APPLICATION FOR THE PLANNING CLEARANCE FOR A BUILDING PERMIT

BLDG ADDRESS: 2710 UNWEEP
 SUBDIVISION: GRIESER
 FILING # 1 BLK # 1 LOT # 1
 TAX SCHEDULE NUMBER:
2945-243-00-180
 PROPERTY OWNER: LOREN GRIESER
 ADDRESS: 2981 MEEKER
 PHONE: 245-4668

DESCRIPTION OF WORK AND INTENDED USE:
2ND STORY REMODEL (EXIST.)
SINGLE FAMILY

Plot Plan

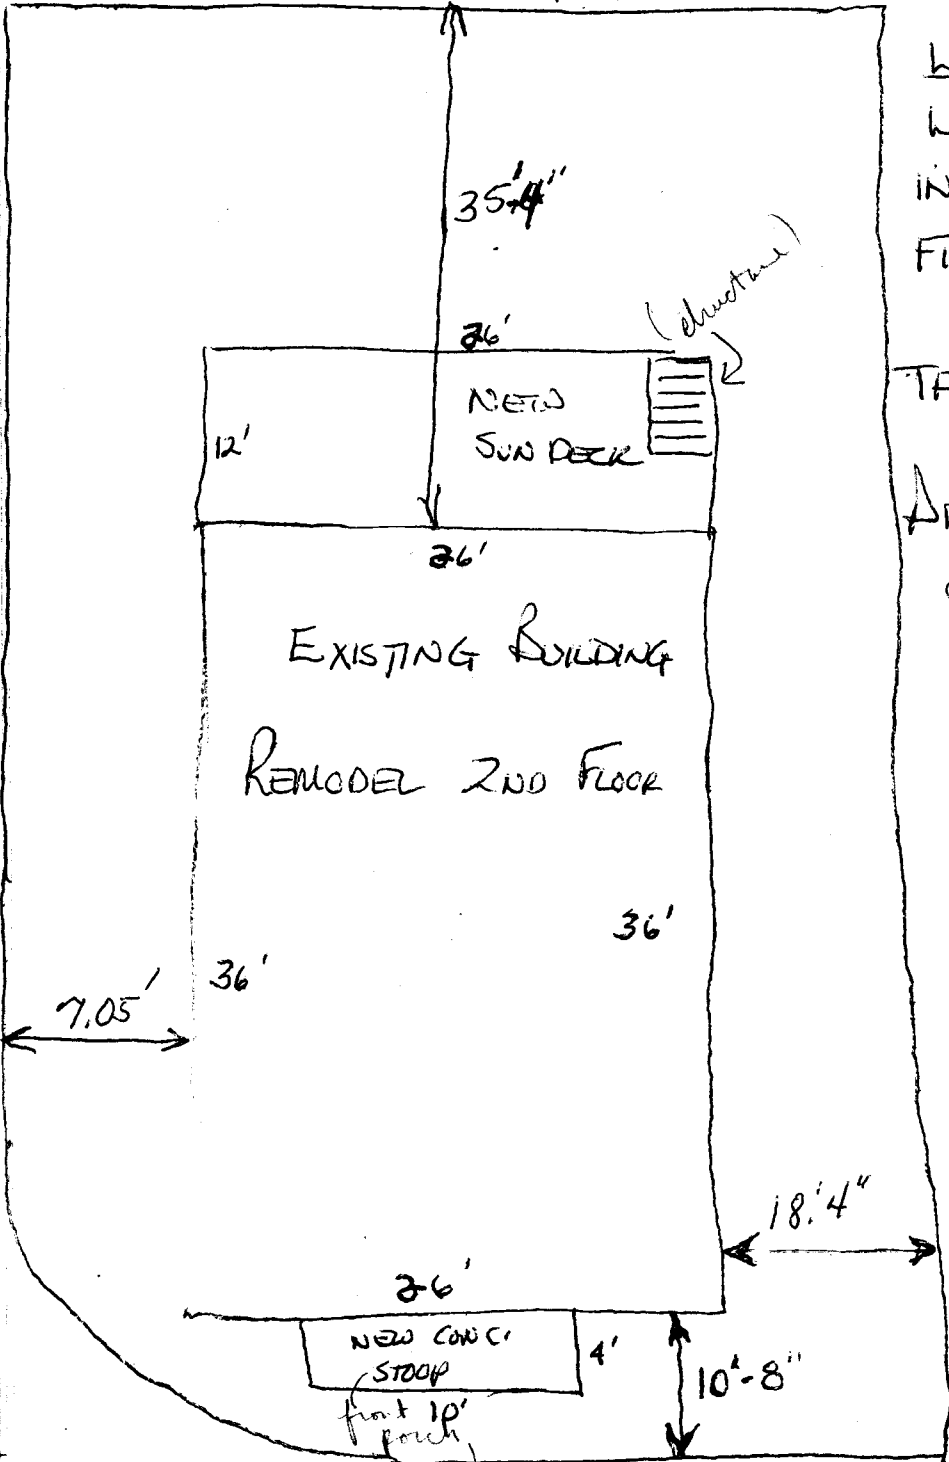
FLOOD PLAIN: YES NO
 GEOLOGIC HAZARD: YES NO
 CENSUS TRACT NUMBER: 13
 SPECIAL CONDITIONS: Structure (existing) non-conforming with reference to setbacks on the front - ① New front stoop must be on-grade slab rather than enclosed ② Deck on rear permissible (setbacks adequate)

Per discussion w/ Bt G., deck allowed on back of lot
front stoop cannot be structure i.e. cannot become enclosed - must
be only on grade slab
